Office Action Summary

10/790,217

YONEOKA, AKIRA

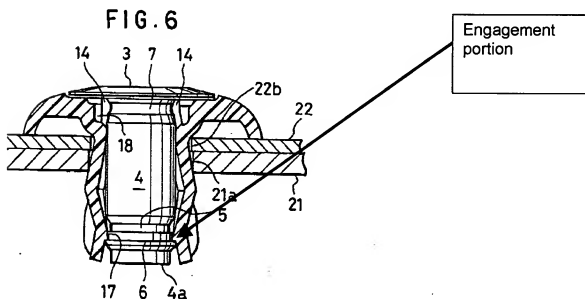
Re claims 1 and 9: Asami teaches a jointing member comprising a pin 1 and grommet 2, wherein the grommet 2 comprises:

- o A flange 10
- o An openable leg 11
- o An insertion hole 8
- o An engagement portion (see arrow in Fig 6 below) at the inner surface of the leg portion

- o A head portion 3
- o An insertable shaft portion 4 with engagement surface 6 (vertical and angled edge) and a lock surface 6 (vertical upper face) are formed at the shaft portion 4.

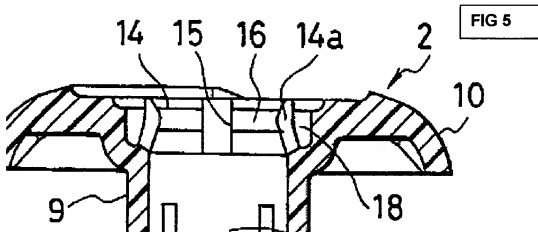
→ **Further Re claim 9 and claim 4:** Wherein the grommet flange comprises: (note the

3 levels of the hole in the flange generally shown in the figure below.

- o A large diameter hole portion (uppermost large-diameter hole, pin head rests in)
- o An engagement hole (assumed hole extending axially below large diameter hole portion, at level of 14 in Figure 5 above)
- o An extending portion (at level of 18 in Figure 5 above) forming a pin-hole portion of smaller diameter than large diameter portion

- o An engagement surface which hold the engagement portion circumferentially displaced to keep the flange open (engagement surface 6 (vertical and angled edge) in a state that the pin is incorporated into the grommet (when the pin is inserted, vertical 6 hold the flange open and aligns with shaft center line) and a

lock surface 6 (vertical upper face) which project circumferentially. Their respective positions enable the pin to slide for a {short but} predetermined distance (the length of the vertical edge of 6) while the grommet and pin are engaged and have the leg portion open.
